Report: TAB Report
Function: Test, Adjust, & Balance
Date: 02/06/2026
Completed By: National TAB

PROJECT
02-16-26 QT #1017 DENVER, NC

Project: 02-16-26 QT #1017 DENVER, NC

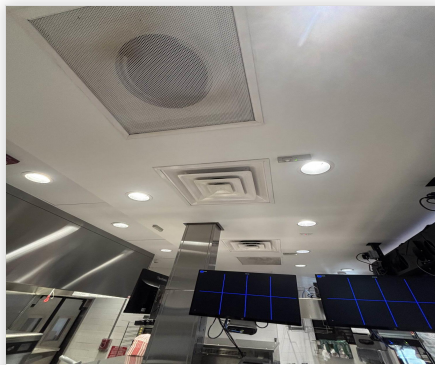
Issue Name : EF-2 overamping at design
Description : EF-2 once sped up to design CFM is over amping at the motor. Combi oven grille is low on airflow, this issue needs to be fixed to bring that grille to design.
Created By : National TAB **Assigned To :** National TAB - Dan Hertenstein
Status : Open
Priority : Urgent **Asset Tag :** EF2
Originated Date : 02/16/2026 - Christian Moller - National TAB

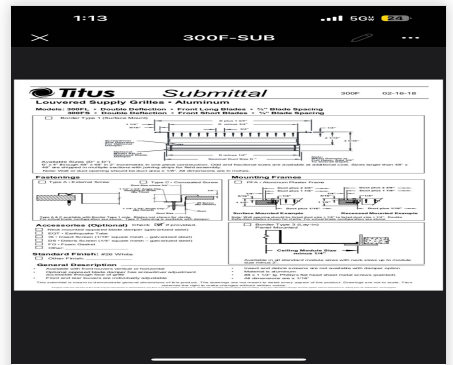
Issue Name : Wrong Cook Line Diffusers
Description : The cook line diffusers for RTU 3 are the wrong models. The Louvered Supply Grilles with adjustable deflection blades are the correct diffusers.
Created By : National TAB **Assigned To :** National TAB - Dan Hertenstein
Status : Open
Priority : High **Asset Tag :** RT-3
Originated Date : 02/16/2026 - Christian Moller - National TAB
